ADDENDUM No. 2

RFP No. 25-57

SOUTH MAPLE PARK AND DEXTER PARK IMPROVEMENTS

**ANN ARBOR PARKS & RECREATION
DEXTER COURT & PAVILION**

HMA COURT PAVEMENT DETAIL (ALTERNATE)
NOT TO SCALE

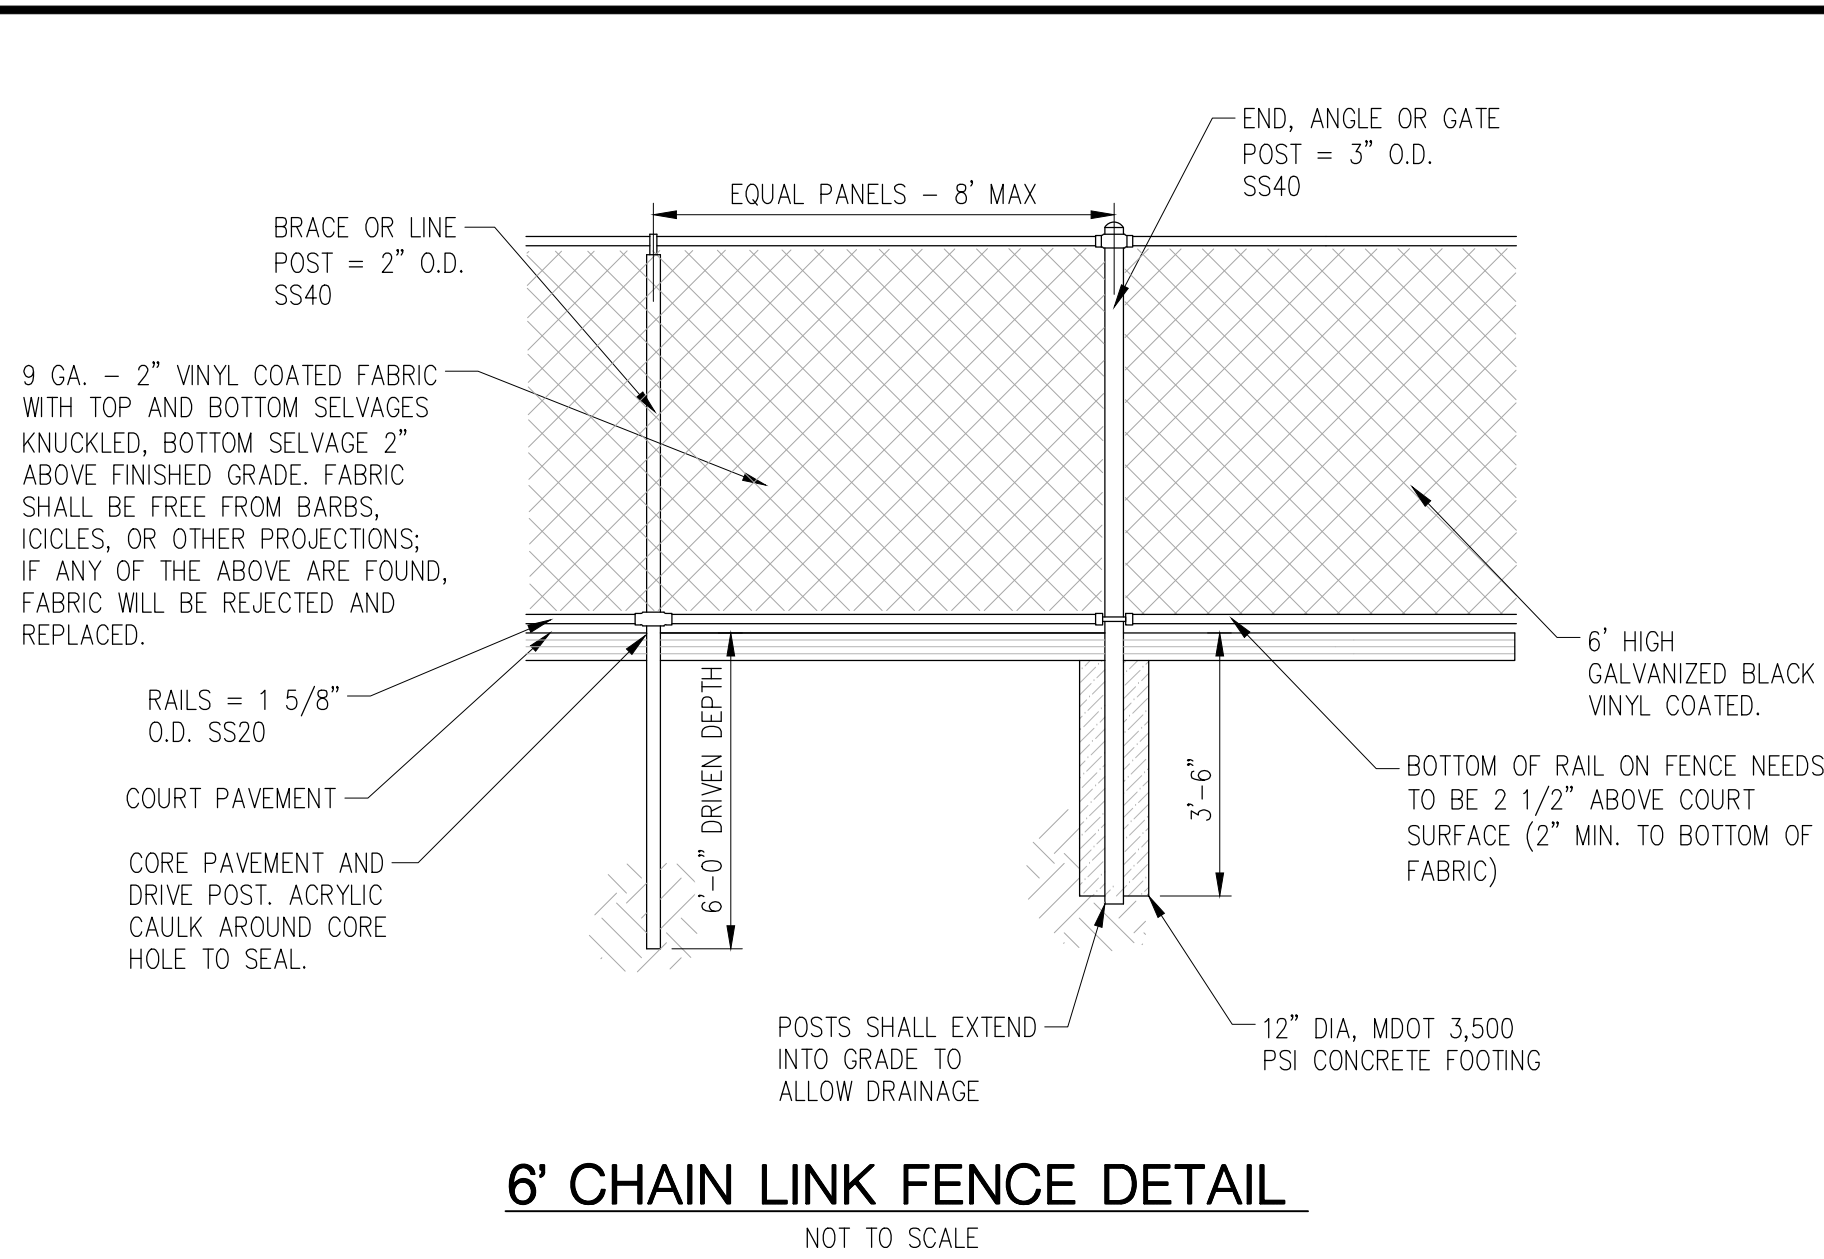
Question 2: Can clarification on the thickness and quantities of HMA paving alternate for Dexter Park be provided?

Answer 2: Yes, the thickness of the HMA alternate at Dexter Park is 3.5 inches. The Schedule of Pricing / Cost and Detail Sheet 5 have been replaced in its entirety through this addendum.

HMA PAVEMENT	RATE PER SYD	THICKNESS	PERFORMANCE GRADE	REMARKS
5EML (TOP)	165 LBS/SYD	1.5"	58-28	RAP IS NOT ALLOWED; AGGREGATE SHALL BE 100% CRUSHED LIMESTONE
3EML (LEVELING)	330 LBS/SYD	2"	58-28	RAP SHALL BE LIMITED TO TIER 1 DESIGN (17% MAX RAP BY BINDER WEIGHT)
BOND COAT 0.05 TO 0.15 GAL/SYD				
AGG. WEAR INDEX (AWI) SHALL BE 200 MIN FOR MAINLINE TOP COURSE
